Change Notification

Change No.: PCN141016CV

FN2200-25-33	FN2200B-25-33	FN2200R-75-34
FN2200-50-34	FN2200B-50-34	FN2200R77-100-35
FN2200-75-34	FN2200B-75-34	FN2200R-2300-99
FN2200-100-35	FN2200B-100-35	
FN2200-150-40	FN2200B-150-40	
FN2200-250-99	FN2200B-250-99	
FN2200-400-99	FN2200B-400-99	
FN2200-600-99	FN2200B-600-99	
FN2200-800-99	FN2200B-800-99	
FN2200-1000-99	FN2200B-1000-99	
FN2200-1500-99	FN2200B-1500-99	
FN2200-2300-99	FN2200B-2300-99

Identification:

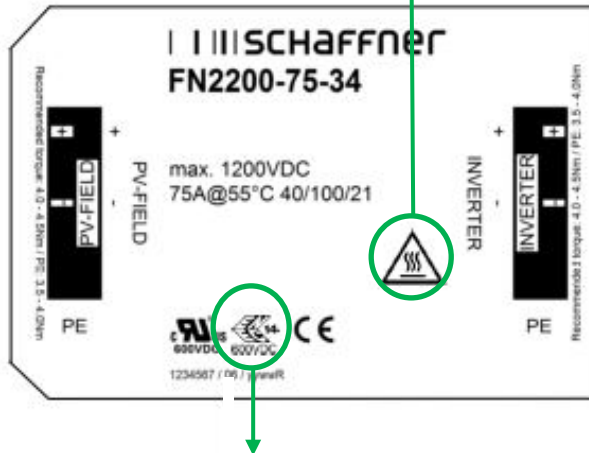
1. Warning label "hot surface" added on label due to upgraded IEC 60939-3 standard.
2. The ENEC certification body changed the interpretation of the new IEC60939-3 filter standard, therefore the ENEC rated DC voltage need to be changed from 850VDC to 600VDC. The voltage indication on the label is now the same for ENEC and UL.

1. A "hot surface" warning.

2. ENEC voltage indication
